**Re: Peer review of hydrology assessment for EIS for the Orana Battery Energy Storage System (Orana BESS).**

Southeast Engineering and Environmental have been engaged to undertake a peer review of the surface water assessment component of the Environmental Impact Assessment for the State Significant Development (SSD) Orana Battery Energy Storage System (Orana BESS).

FIGURE 1: Site topography and hydrology - Peer review of surface water risks for Orana Battery Energy Storage System (Orana BESS).

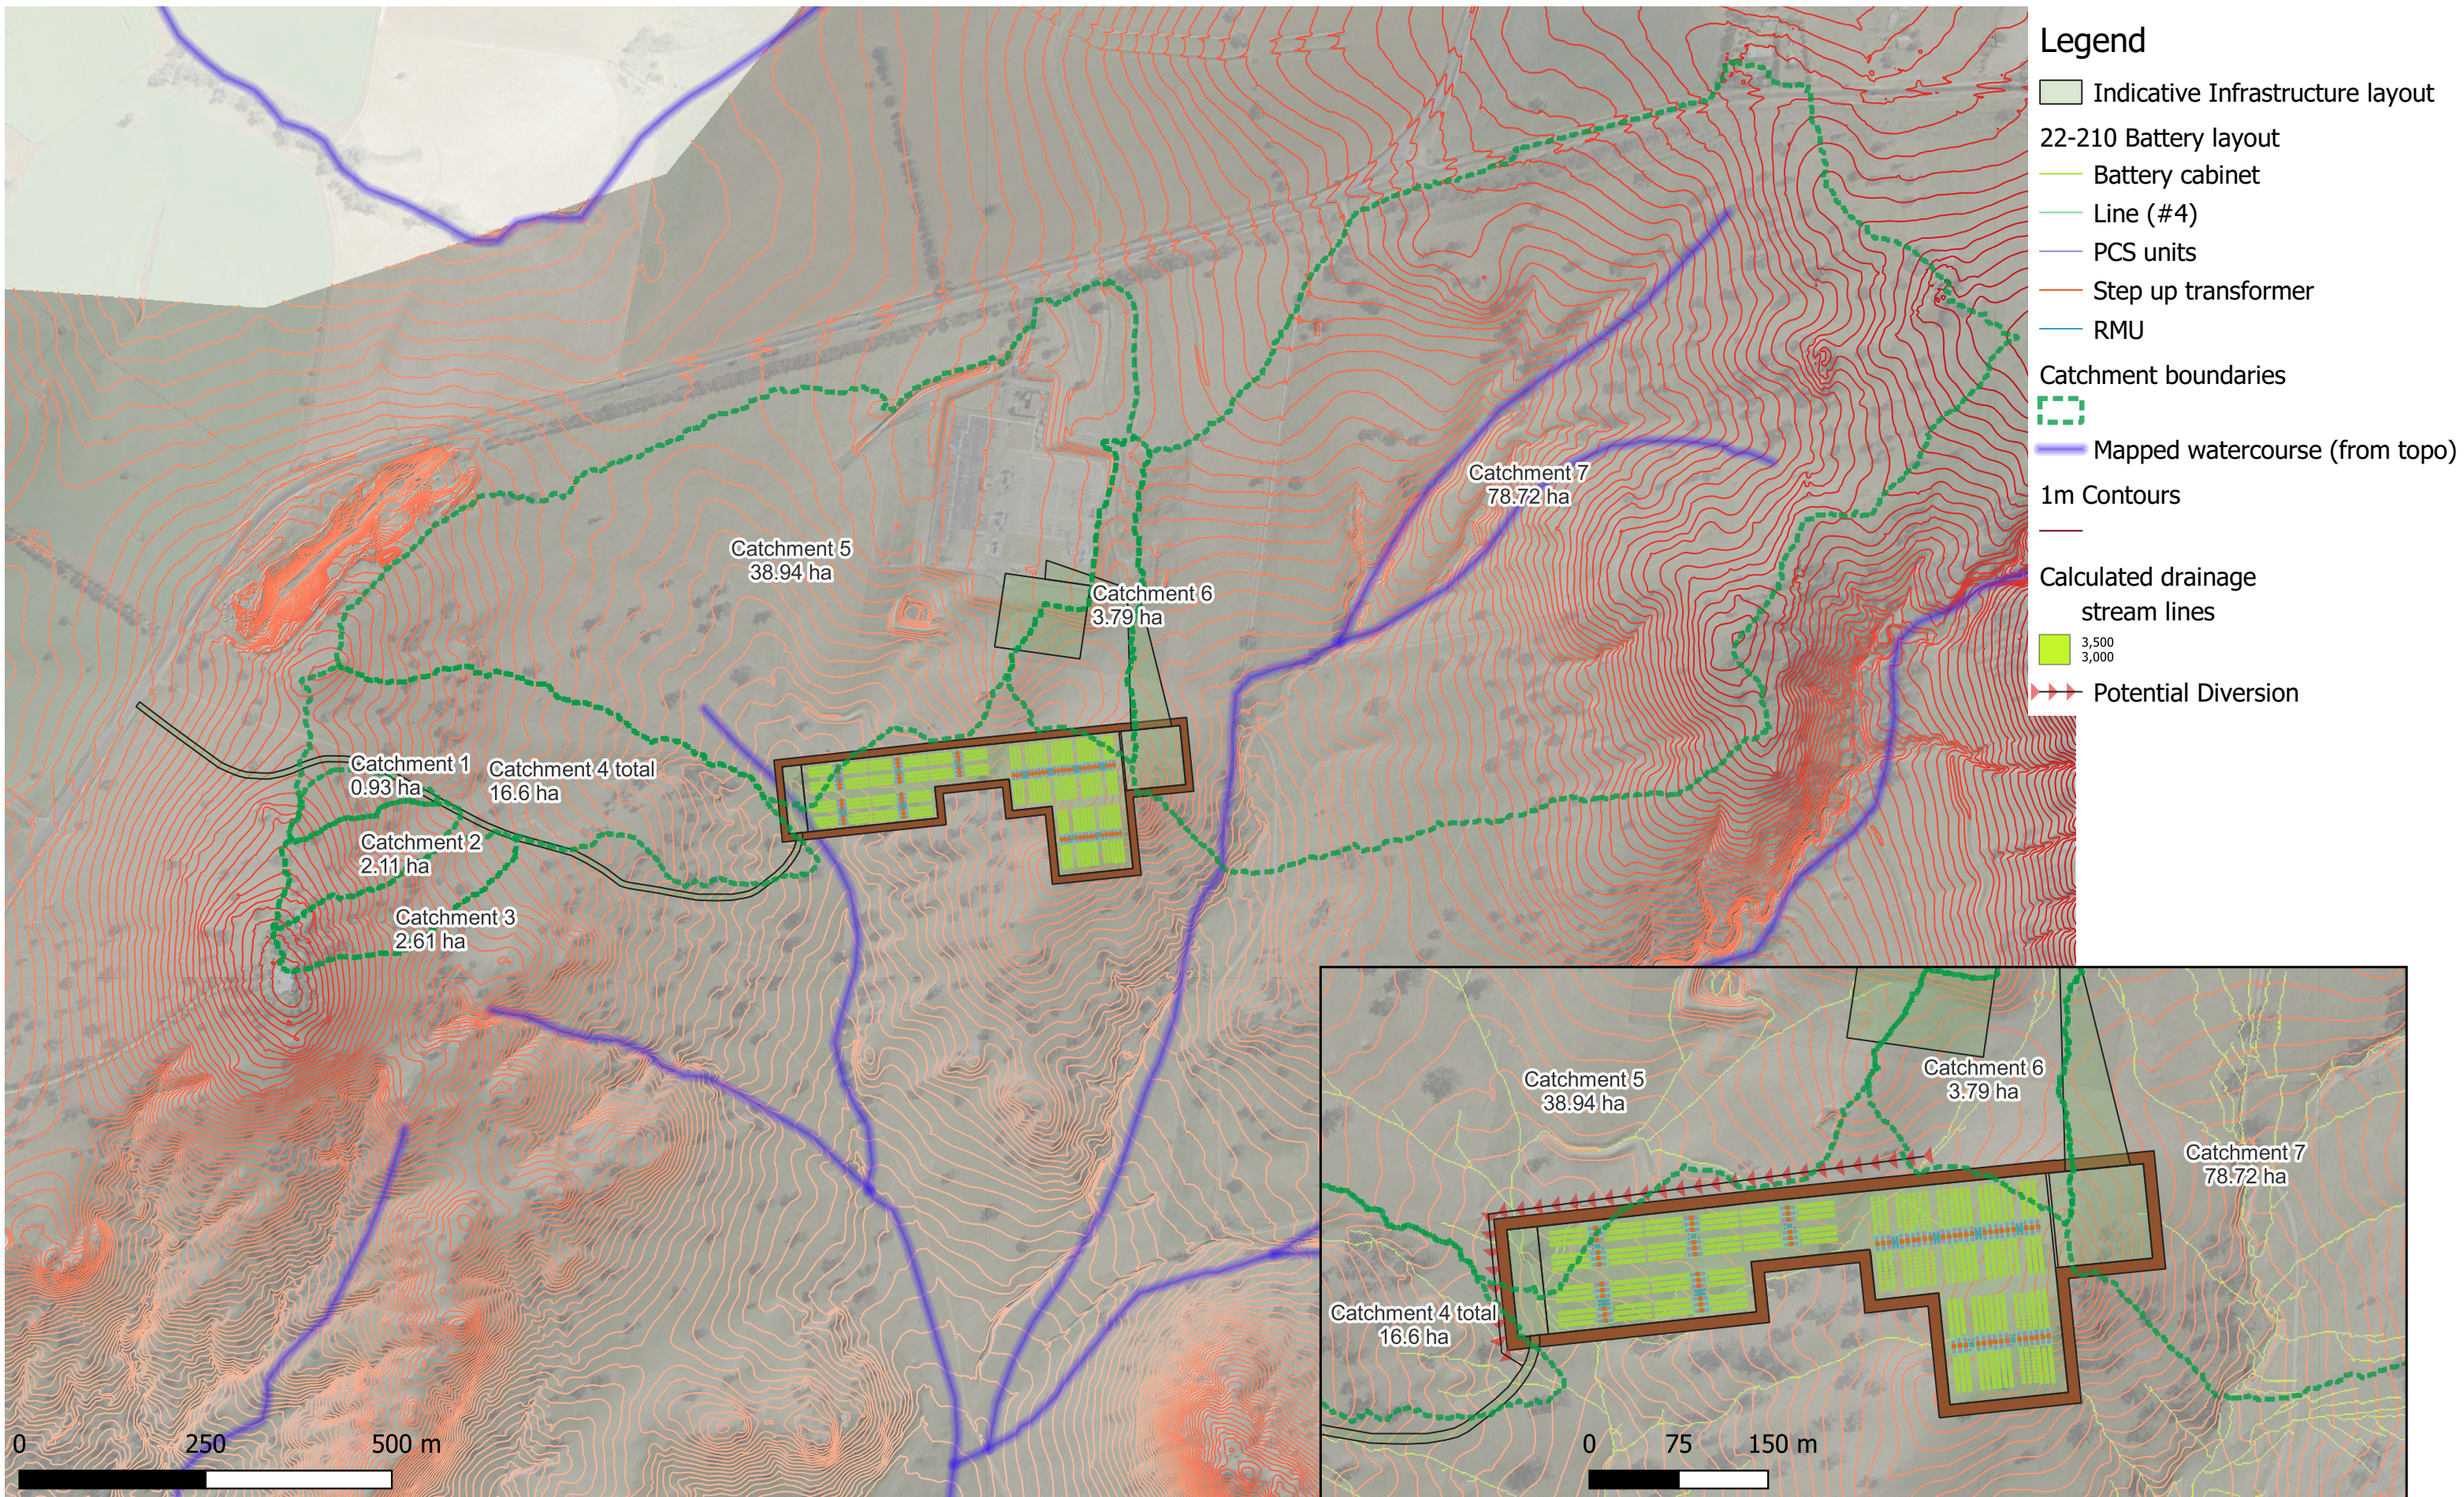
The access road traverses a number of small drainage depressions from approximately 0.9 to 2.6 ha (Catchments 1, 2 and 3). Flows from these catchments can be managed with standard culvert road crossings.

*Management of flows in this area is low risk and can be managed with standard unsealed road design and road culvert designs.*

The western end of the BESS area sits across a mapped first order watercourse, intercepting a catchment of about 43ha (Catchments 5 and 6) as well as the lower end of a 16.6ha catchment to the east (Catchment 4). Diversion of flows up to the critical design event will be necessary to provide flood protection for the BESS area and to transfer catchment flows in a stable manner to the existing natural watercourse below the site. The Regional Flood Frequency Estimation Model (RFFE) estimates the median 1% AEP flow for combined catchments 5 and 6 at 11.3m<sup>3</sup>/s, and for combined catchments 4, 5 and 6 at 15.5m<sup>3</sup>/s.

*The BESS area intercepts natural drainage from significant catchments that generate significant flows. Flooding and runoff from this area presents a high risk of impact to the development, both during construction and during operation. Detailed hydrologic and hydraulic analysis of these catchments will be necessary, along with the design and integration of a diversion structure with the BESS platform design to provide long term flood protection for the BESS and to transfer catchment flows in a stable fashion to the natural watercourse below the BESS site. A freeboard of at least 500mm for all infrastructure above the 1% AEP flood event, incorporating future climate change intensity estimates should be provided.*

A second order watercourse runs to the east of the site draining a catchment of 78.7ha (Catchment 7). The site is at least 5m above the watercourse in this area. The Regional Flood Frequency Estimation Model (RFFE) estimates the median 1% AEP flow for this catchment at 19.6m<sup>3</sup>/s. Channel grade is approximately 2%. Using a simple mannings equation approach, flow depth for this flowrate in this watercourse is about 1m deep, suggesting that the BESS area will be well above the 1% AEP flood level.

*Although in close proximity there is significant vertical distance between the watercourse to the east and the BESS and substation area. This watercourse presents a low to medium risk to the development. The BESS and substation level should be checked against flood levels within this watercourse to confirm that a minimum of 500mm of freeboard is achieved from this watercourse.*
